Donald Insall Associates
Chartered Architects and Historic Building Consultants

C COPYRIGHT & DESIGN COPYRIGHT & DESIGN RIGHT 2008	PROJECT/SITE ADDRESS: ROCHDALE TOWN HALL TOWER LIFT SHAFT	GLASS & GENERAL www.glassandgeneral.com Unit 4 Heathway Industrial Estate Manchester Way Dagenham Essex	REVISIONS		DATE 17/12/22		DRAWN by RZH	
			01 - Details changed21.12.2022		CHECKED byProject M.			
			02 - Dimensions & details changed02.01.2022		SCALE 1:30@A3		Rev. 02

DRAWING REF. 01			
	TEL:	Rm10 8PN Tel: 0845 371 4450 Fax: 0845 371 4455	Note: CDM regulations will apply to status approval of drawings and manufacture will only commence on receipt of 'A' status approval of drawings issued. C = TO BE AMENDED - Drawings to be resubmitted. B = APPROVED WITH AMENDMENTS - Drawings to be resubmitted with final amendments included. A = APPROVED FOR PRODUCTION, NO COMMENTS - Procurement of materials, manufacture and installation to commence.		DRAWING TITLE Plan. Section 1-1

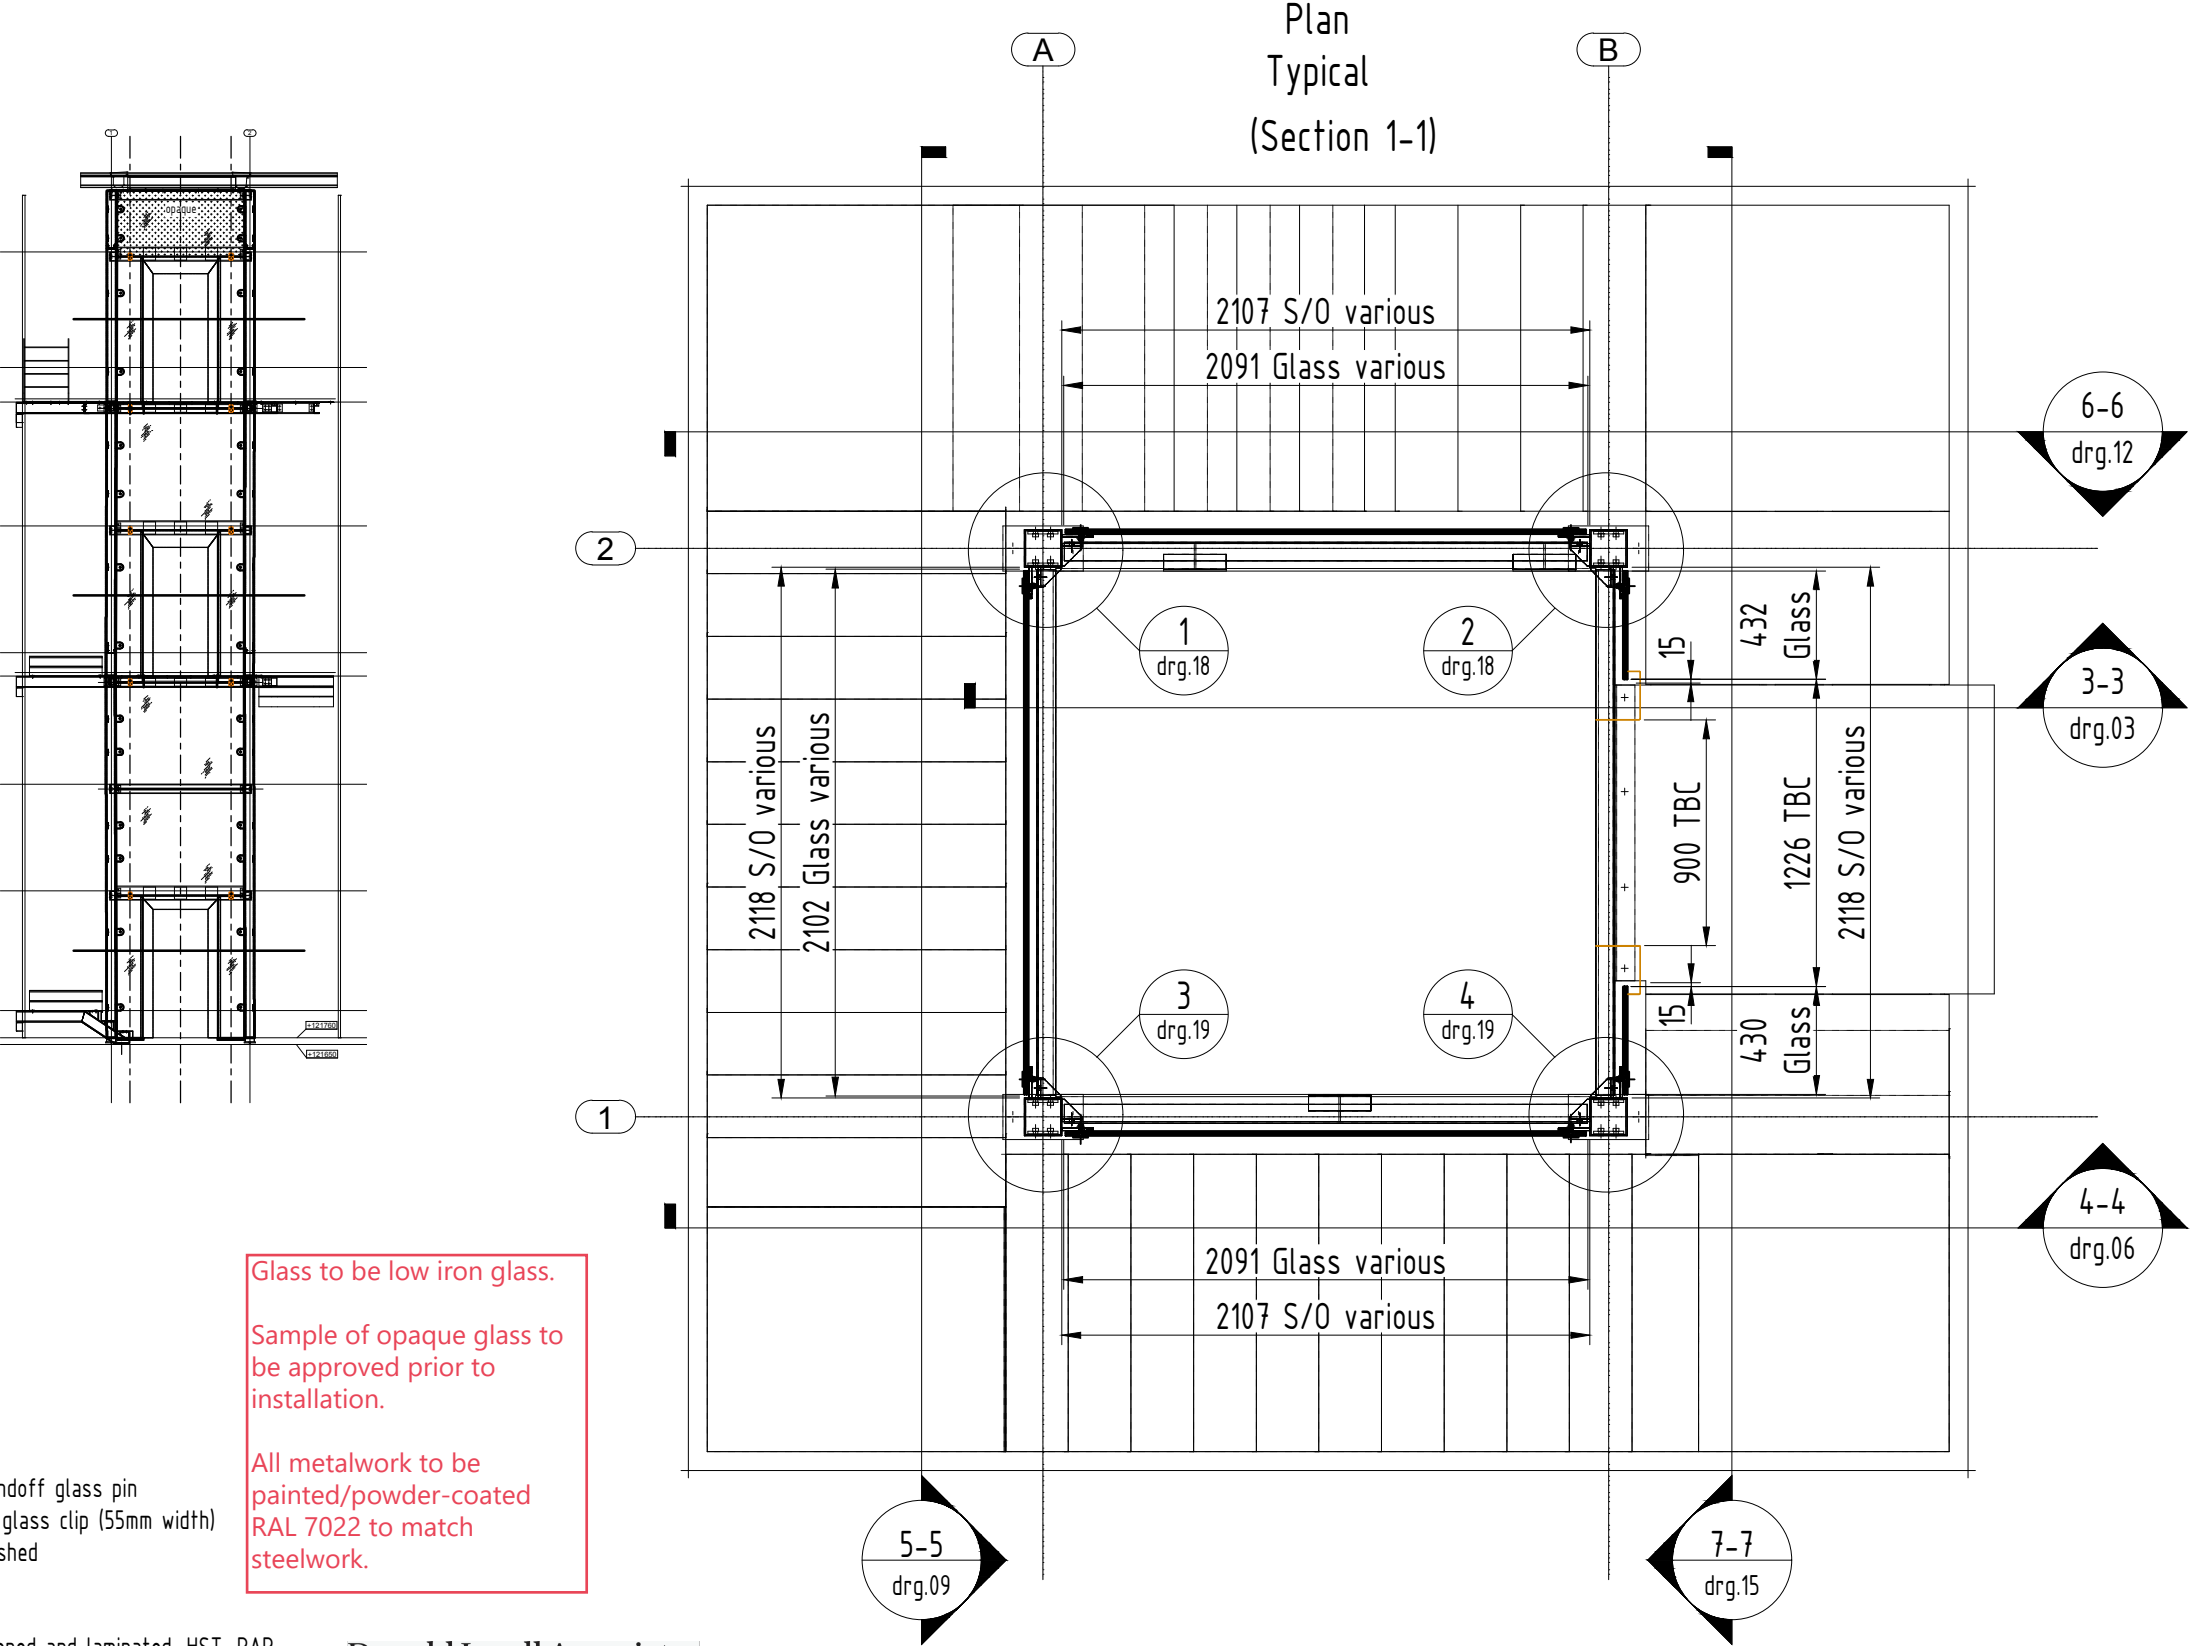
Glass to be low iron glass.

Sample of opaque glass to be approved prior to installation.

All metalwork to be painted/powder-coated RAL 7022 to match steelwork.

A	No Comment:
B x	Amend as noted:
C	Amend and re-submit:
D	Not inspected:
Date Received: 03.01.23 Date Returned: 27.01.23	
Checked by: RZM

Section 7-7. Part 1 of 3

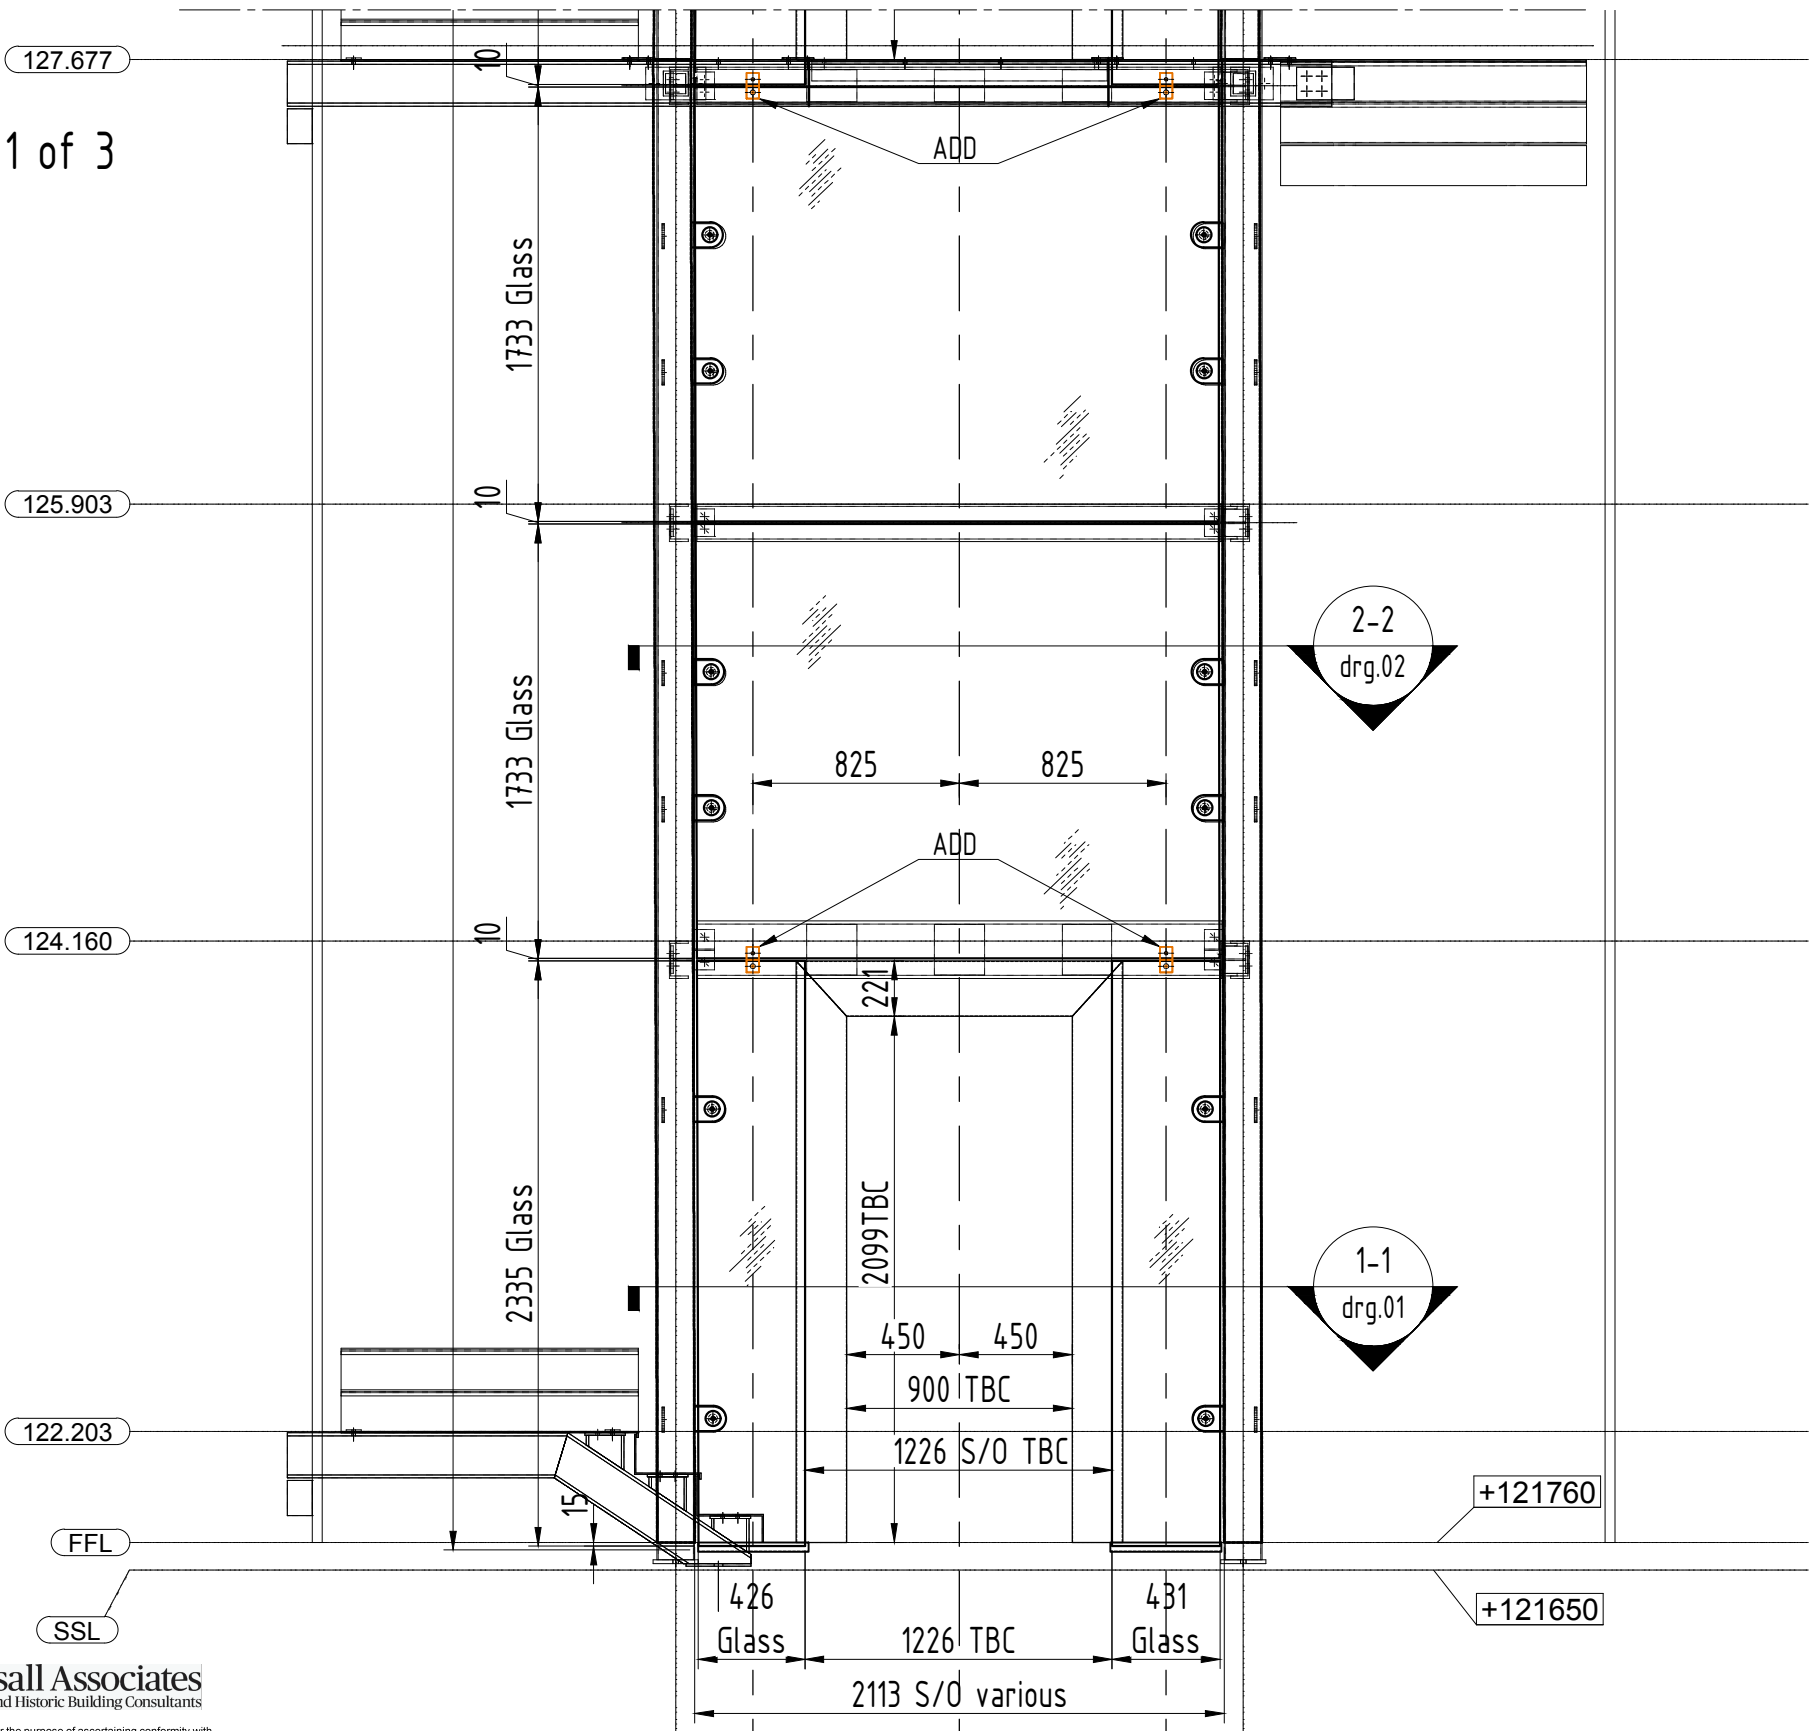
Approved on the basis a metal architrave is provided in Rymex bronze to close the gap between glass and lift shaft door installation. Details to be reviewed and agreed on site post installation of the glazing.

Section 7-7. Part 2 of 3

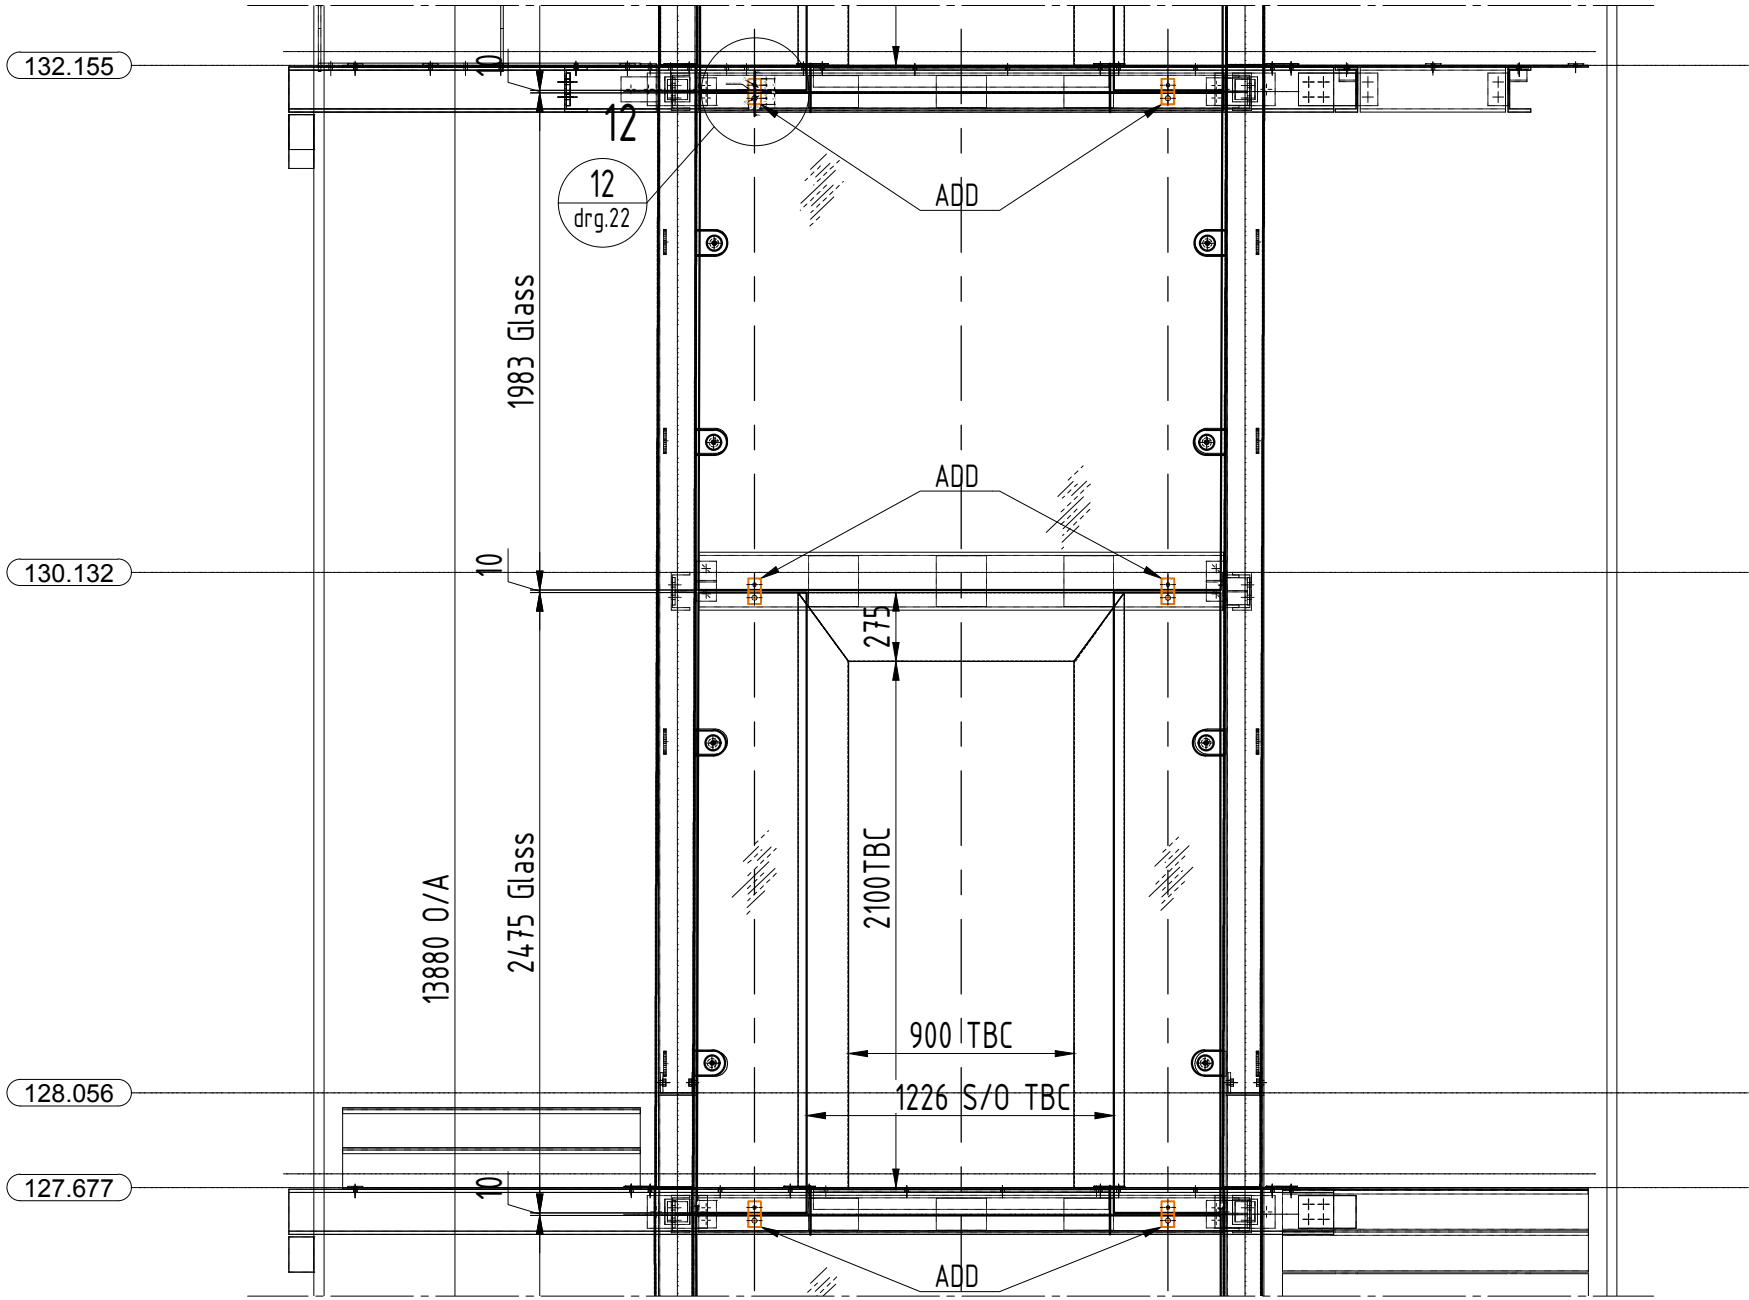
Approved on the basis a metal architrave is provided in Rymex bronze to close the gap between glass and lift shaft door installation. Details to be reviewed and agreed on site post installation of the glazing.
